Previous Dante Accelerator Firmware version information

V4.0.1

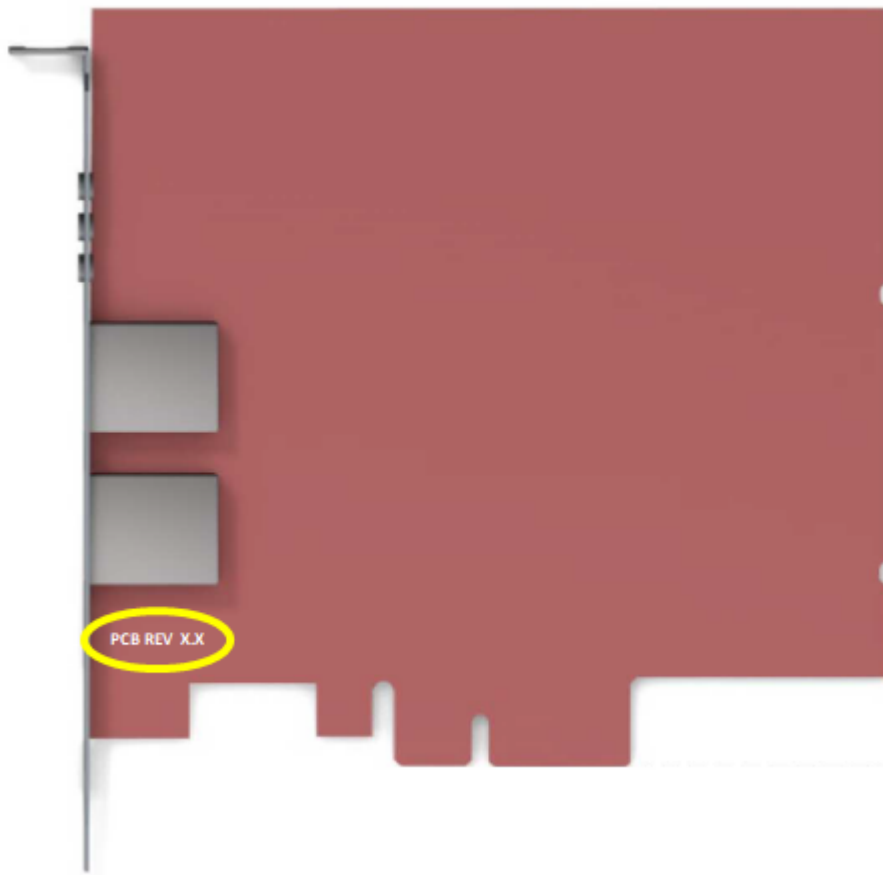
- Now supports AIC128-D revision 3.1 (PCB REV 3.1).

The AIC128-D firmware V4.0.1 is only for the revision 3.1 (PCB REV 3.1). This update is not required if using AIC128-D revision 3.0 or earlier; continue to use V4.0.0 or V3.0.0 unless otherwise necessary. The revision number of AIC128-D is printed on the part enclosed by the ellipse in the figure below. Make sure to confirm the revision before updating.
